BUILDING INSPECTION PERMIT

This is to certify that Wescott & Payson Li/Chris Ballard
has permission to Construct 2424 s.f. Single family dwelling w/2 car garage
AT 36-38 Yale St (Lot #2 University Park) CITY OF PORTLAND
OBL 436 A012001

City of Portland, Maine - Building or Use Permit

RE: 36-38 Yale Street (lot #2 University Park) – 436-A-012 & 1/2 of 13 – R-3 Zone
Permit application #03-0894

SCHEMATIC GARAGE SECTION

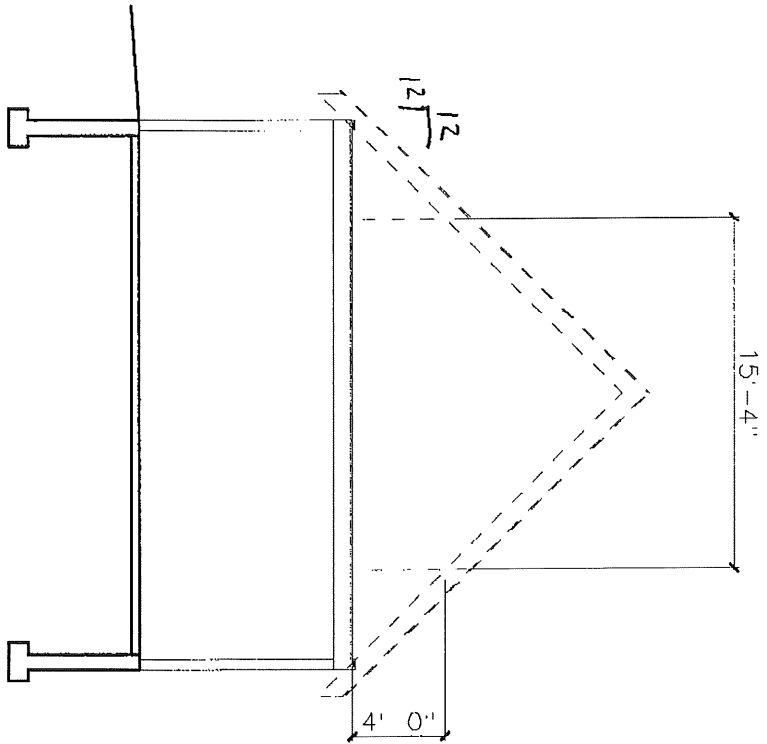
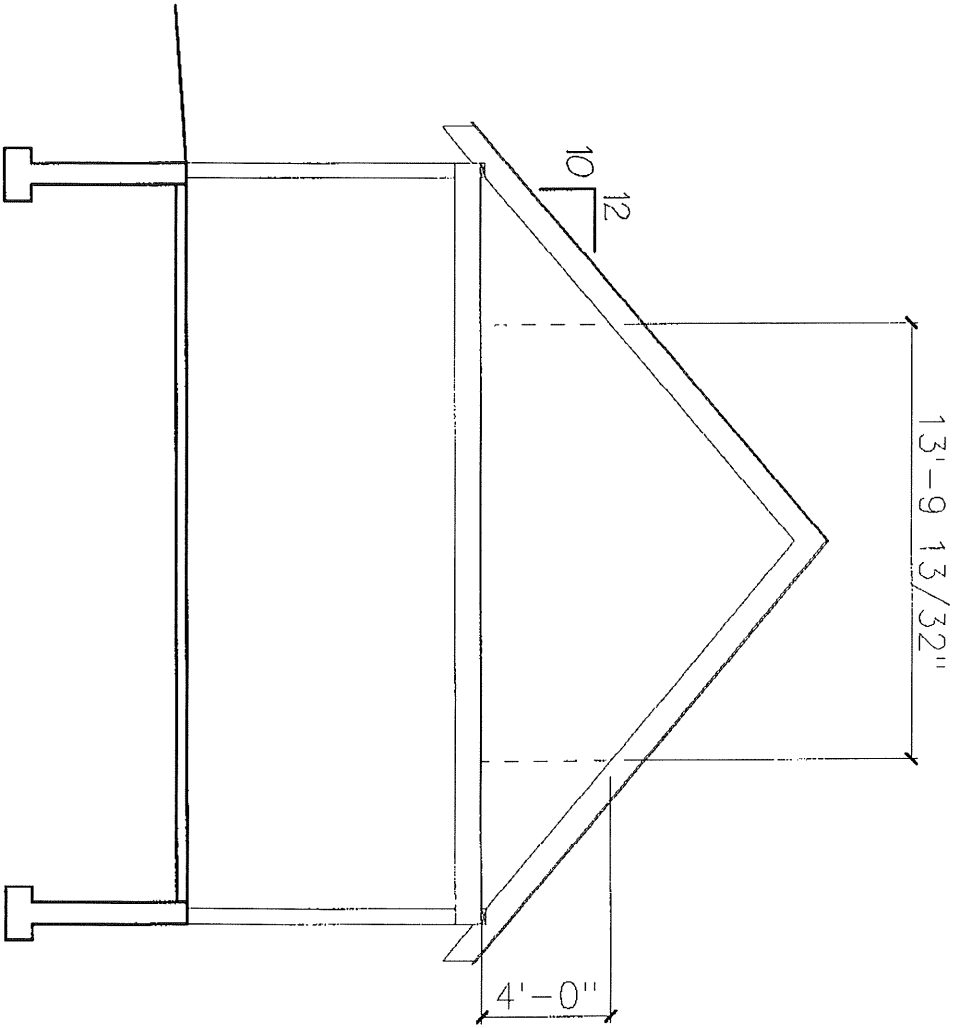
In order to revise the 1/2 story "Bonus Room" over the garage, I will need clarification on these points of the code:

- 1) Is the AREA of the 1/2 story measured *only* within an occupied space, or does it include unoccupied space?
- 2) Is the AREA of the 1/2 story calculated by measuring 'gross', to the outside of walls, or 'net' to the inside of the walls?
- 3) Is the story below calculated by measuring 'gross', to the outside of walls, or 'net' to the inside of the walls?
- 4) Is the 4'-0" height measurement taken from the top of floor sheathing to the underside of the structure, or from top of floor sheathing to the top of the roof sheathing?

Clearly, all of the initial discussions assumed that the interior of the finished space was the only area to be counted. If this does not hold true, then in order to maintain the architectural integrity of the dormer design, we will have to lower the roof pitch from 12/12 to 12/9.

Comments: The Area measured is from the 4' height per the ordinance Definition. — If on the Garage floor plan that was original submitted, the walls are at the 4' level (I thought you said differently during our ^{last} phone conversation) and there is no dormer, then your proposal would work.
Please confirm — Marge

COND FLOOR PLAN

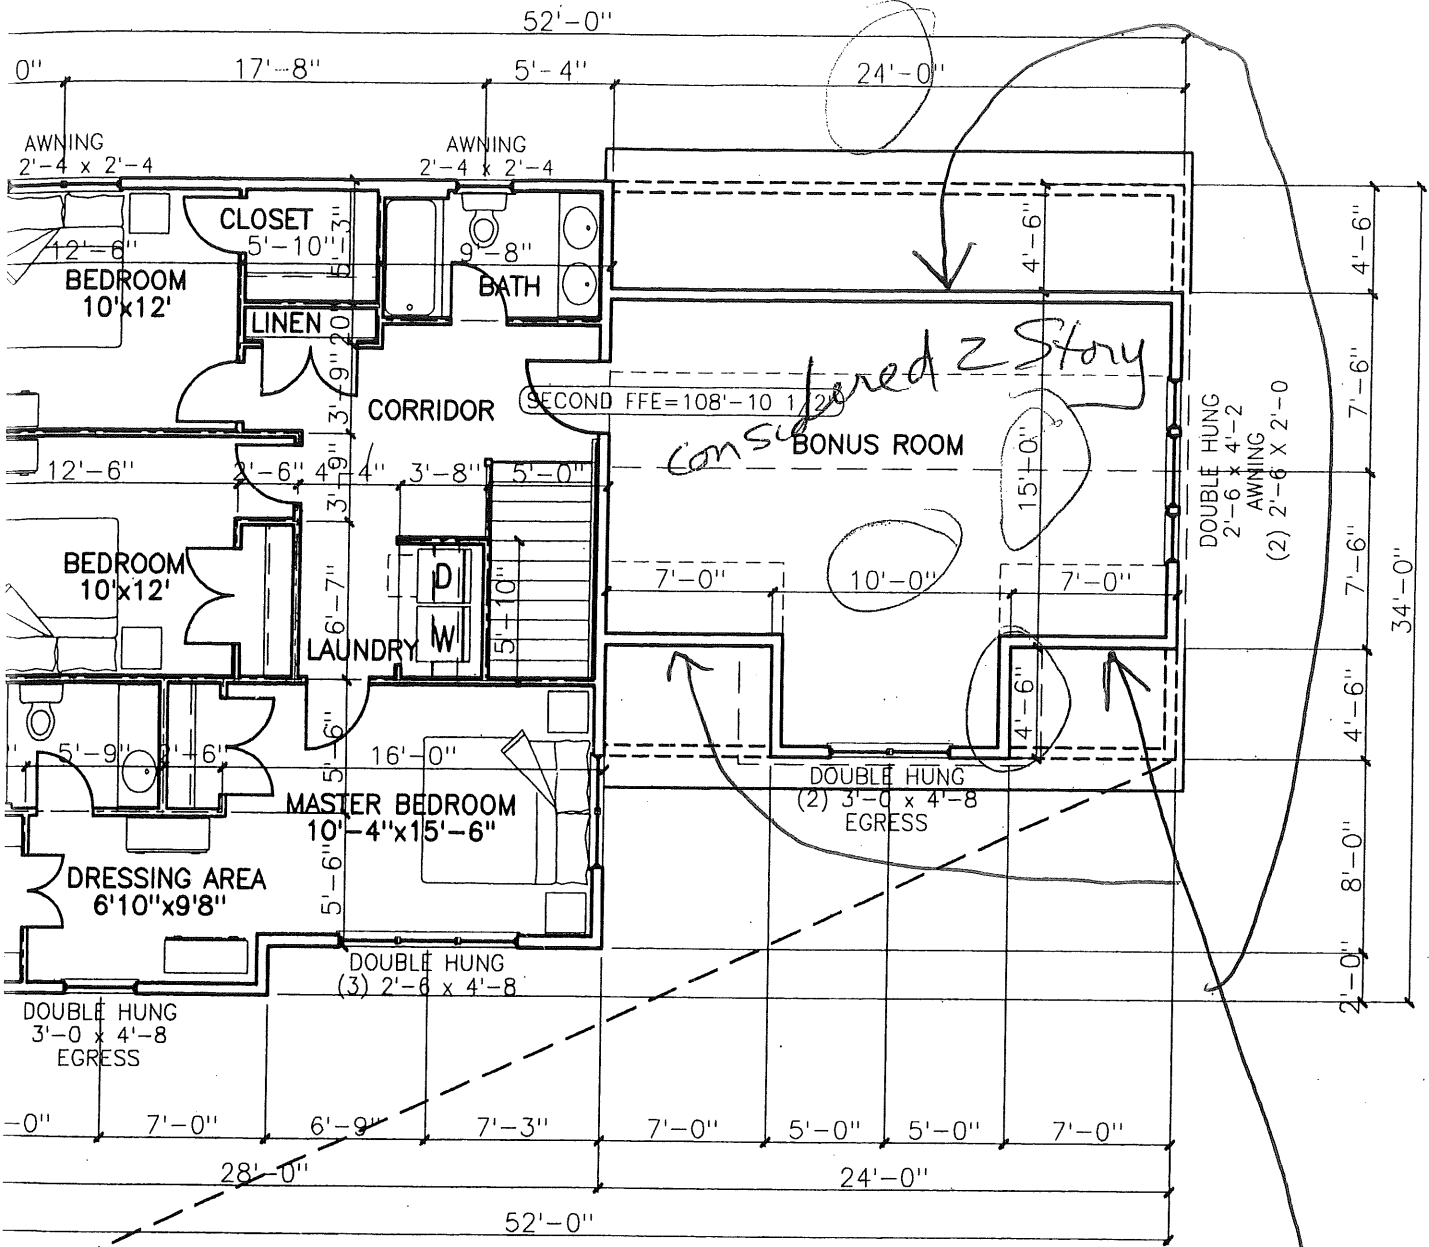
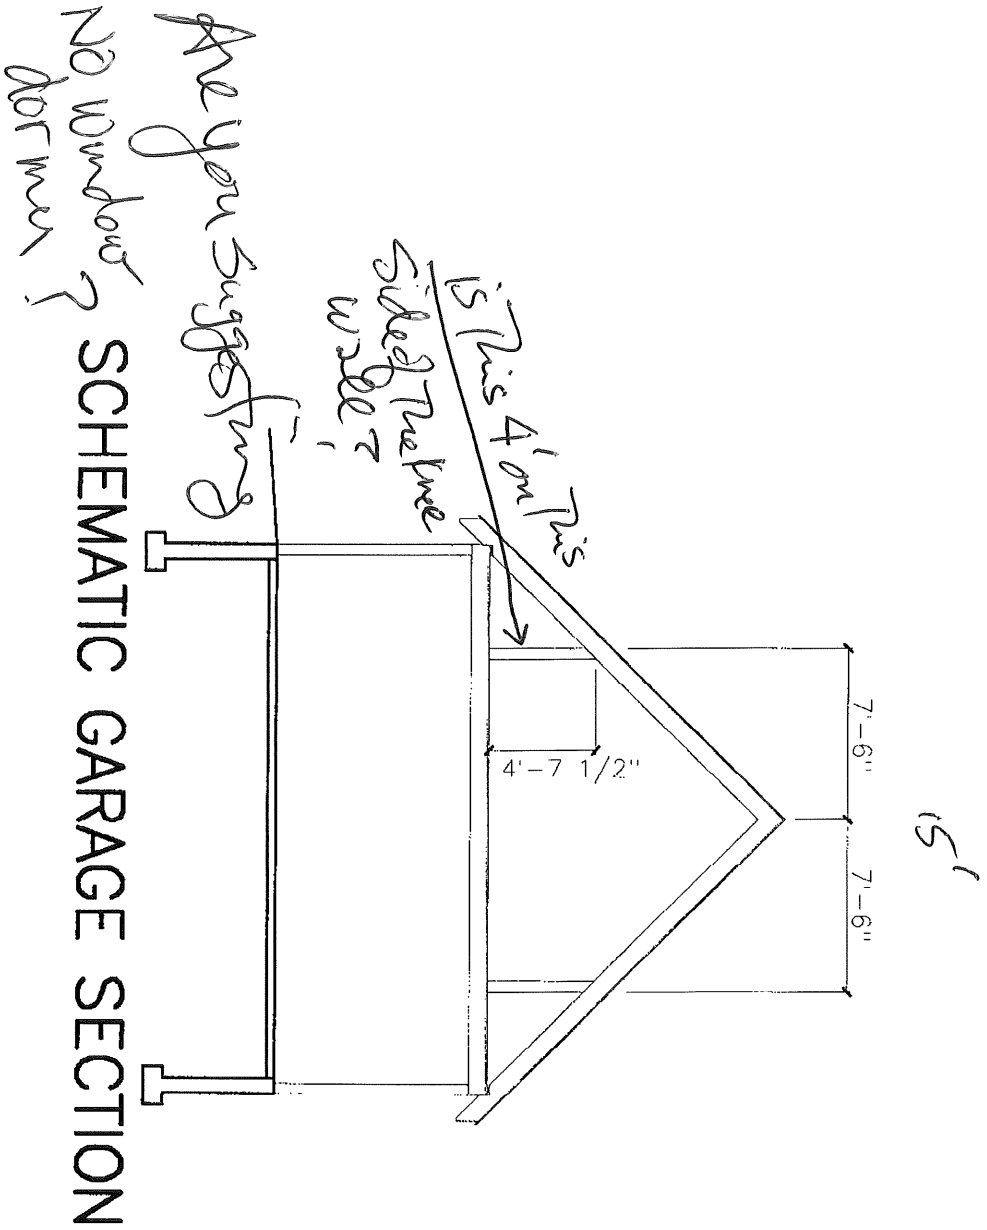
I have developed a revised building section with a 10/12 roof pitch which will bring the entire garage within the 1 1/2 story guidelines as we have discussed. (See attached.)

It has occurred to me, however, that the 1 1/2 story requirement might apply only to the area of the garage being constructed inside of the 15' setback? Thus, we would consider only the 7' of the garage width, and bonus room width, in the calculation:

Garage: 24' x 7' = 168 s.f. x 2/3 = 112 s.f.

Bonus room at 48" with 12/12 pitch: 15'-4" x 7' = 107.3 s.f.
(See attached)

$24 \times 24 = 576 \text{ sq ft} \times 0.66 = 380.16 \text{ sq ft}$ MAX on 2nd floor
to use 1/2 story set back

$15 \times 24 = 360$
 $4.5 \times 10 = 45$
 405 sq ft considered 2 stories

FRONT ELEVATION

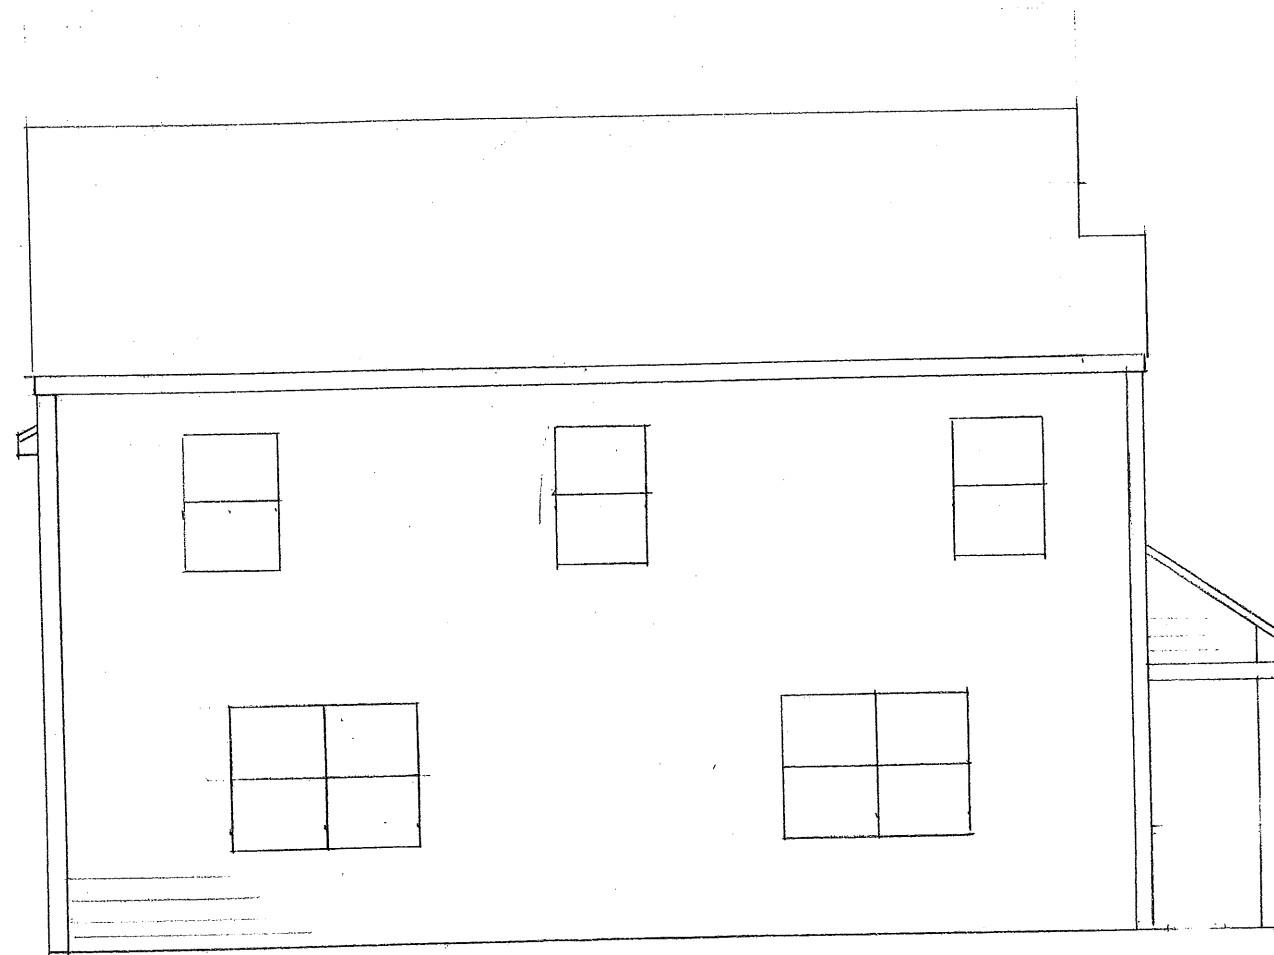
*See Revision
9/8/03*

TITLE:
LOT 2
BUILDING LAYOUT
CWS ARCHITECTS
SCALE: 1"=20'
DATE: 8-4-03
JOB #: 4080

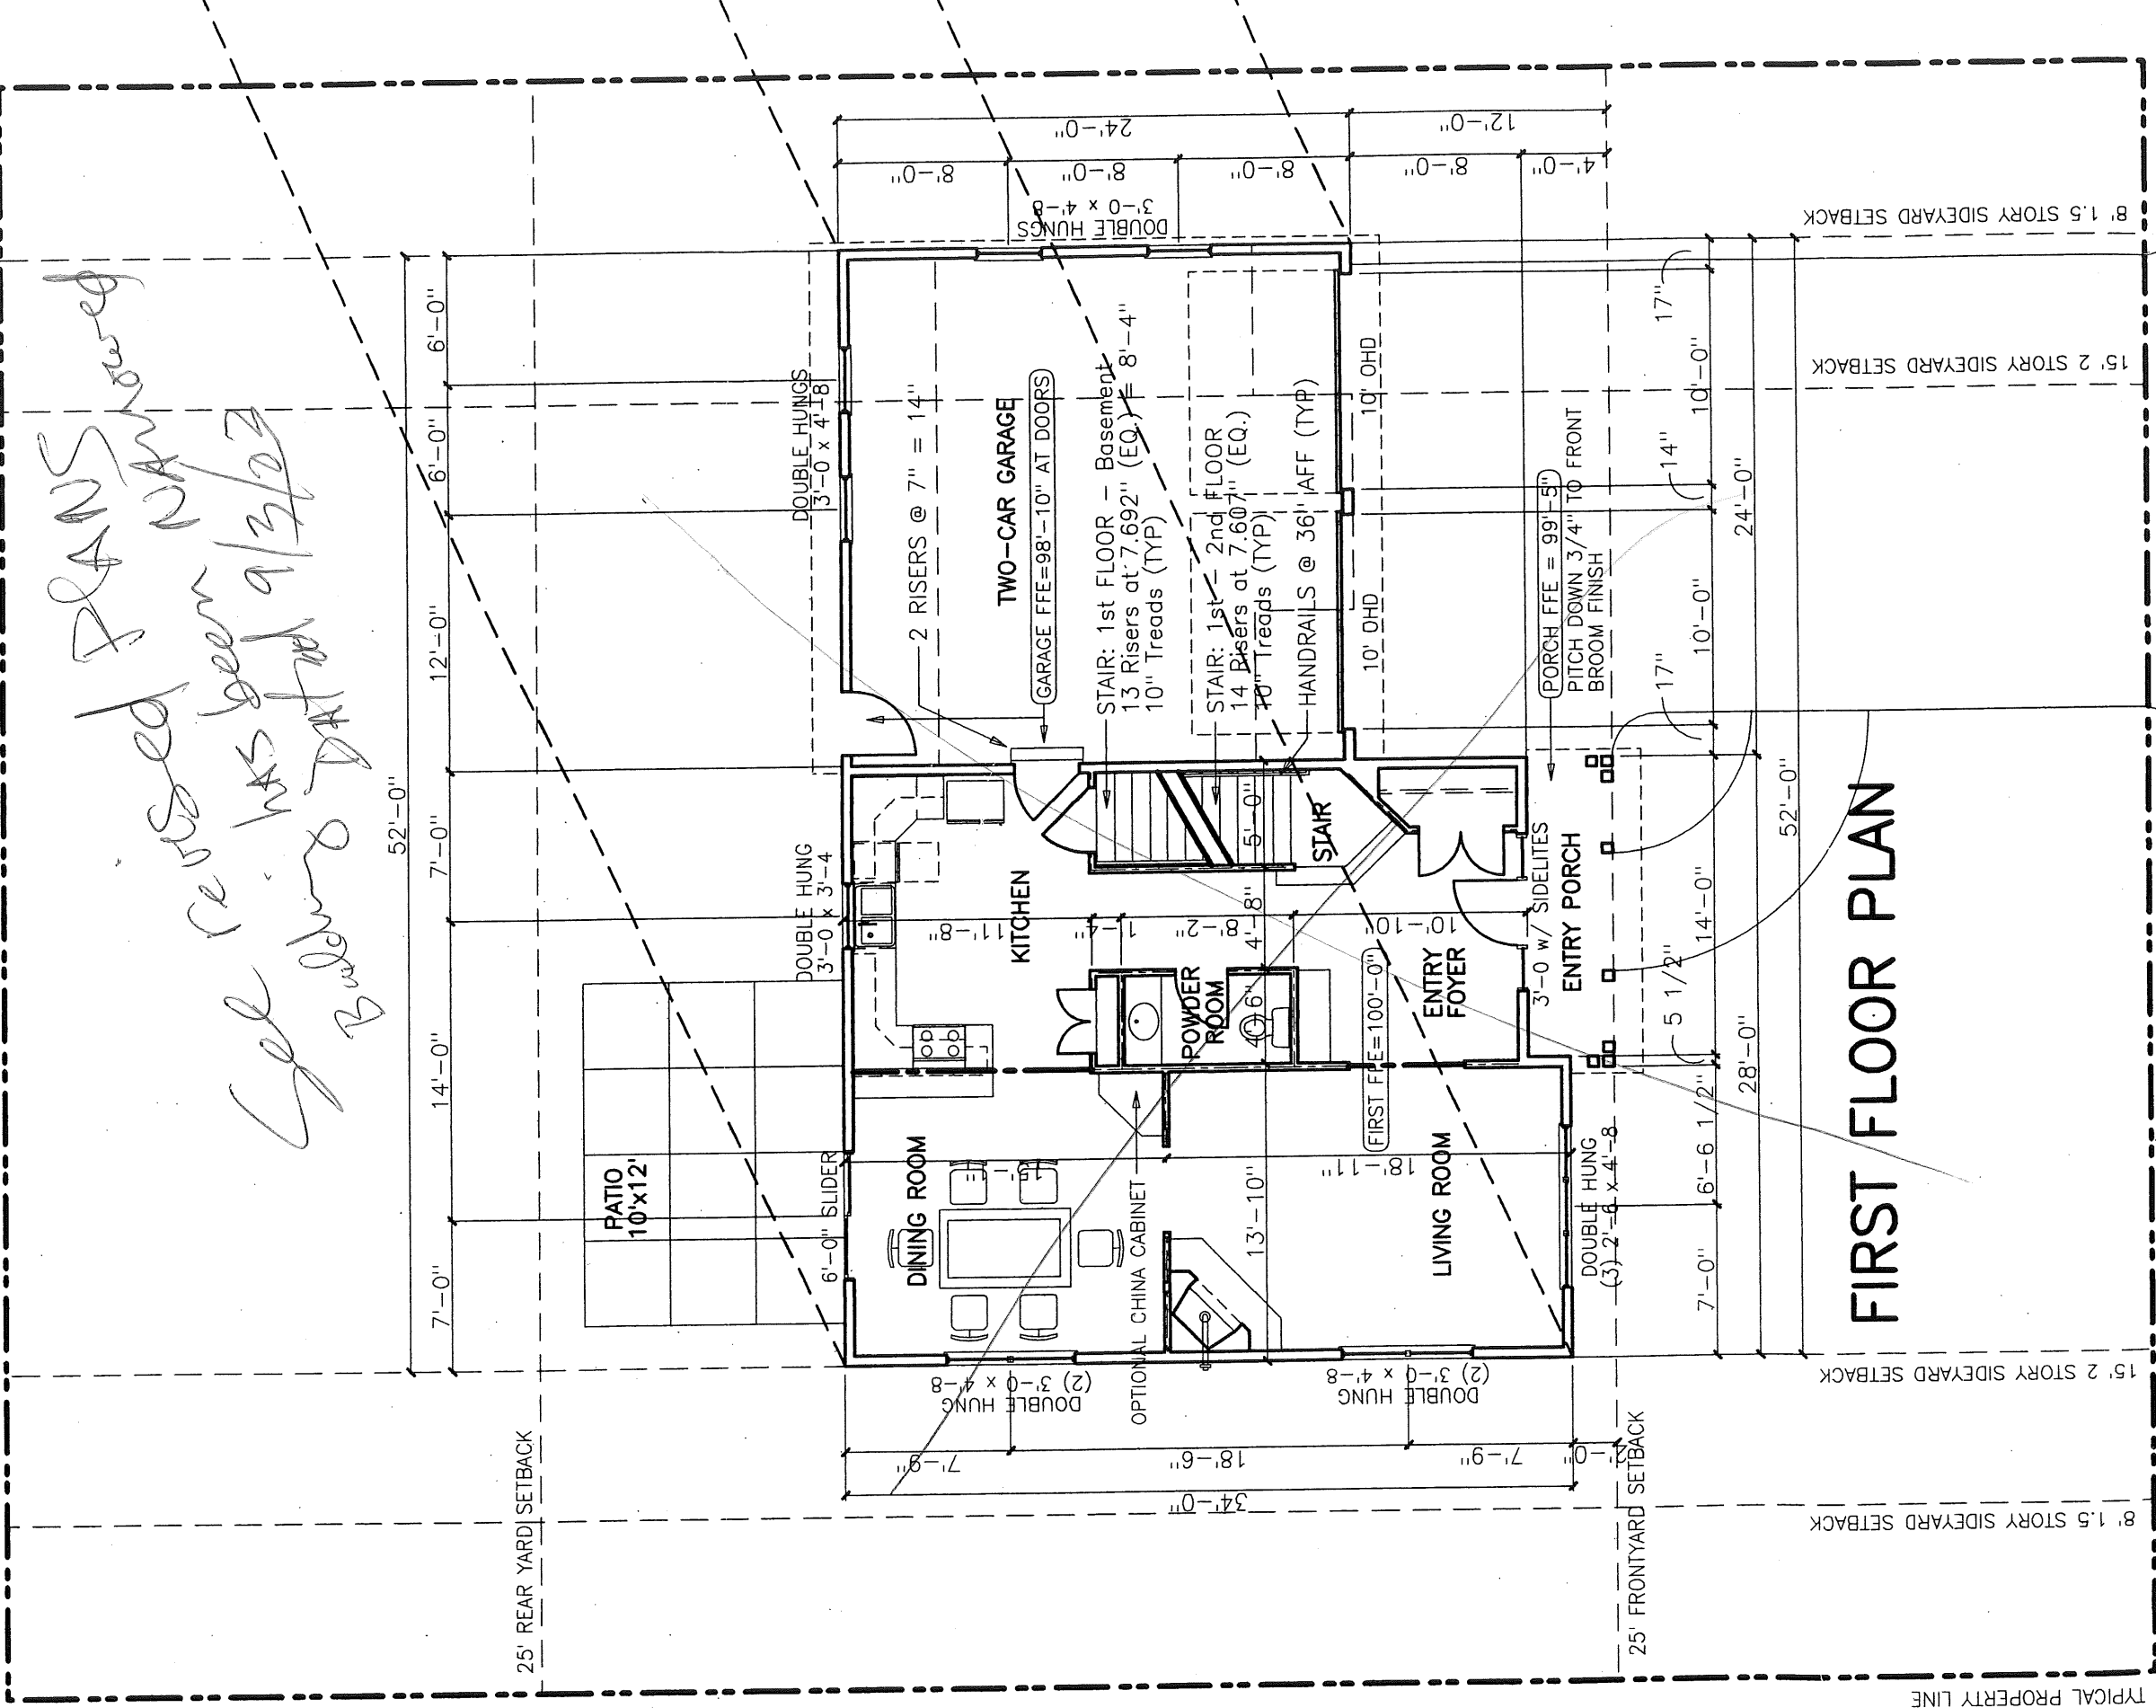
Revised site plan
 which reduces the size of the
 Building

revised plans 9/3/03 24'6" x 36' ~~22' x 34'~~

Side Yard - 14' req - 8' 15" shown 14' 3" & 14' 3" shown
